Confirmation of requirements in latest GTR 15

Sep. 2017
JAPAN

Japan would like to confirm understandings regarding following paragraphs in GTR 15.

■ Annex 5 3.3.1.3.(a)

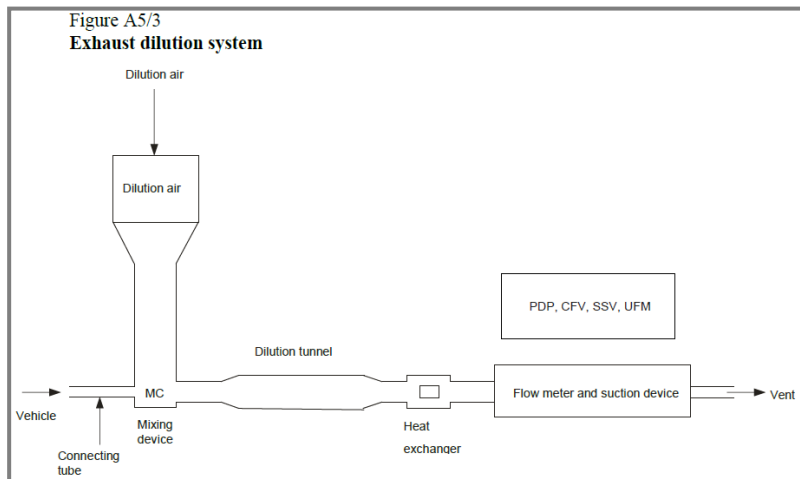
If not measuring PM/PN for gasoline vehicles, we think Annex 5 3.3.1.3. (a) does not need to apply. Is our understanding correct?

(Most gasoline exhaust gas dilution system in Japan does not need to measure particulate that there exists the system without tunnels.)

Comparison of general emission measurement system at EU and Japan

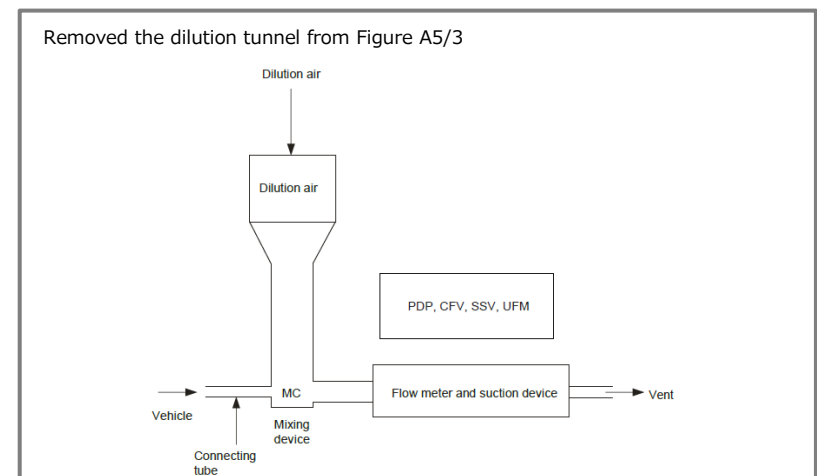
- Emission measurement system on GTR No.15
The requirements of exhaust gas dilution system are written based on the system with dilution tunnel. (see Fig. A below)
- Emission measurement system on attachment 42 (JC08 mode test)
Since PN/PM measurement is not required in Japan, many the gasoline exhaust measurement system does not have dilution tunnel. (see Fig. B below)

- Figure A: Included to measure particulate matter

- Figure B: Measure only gaseous emissions
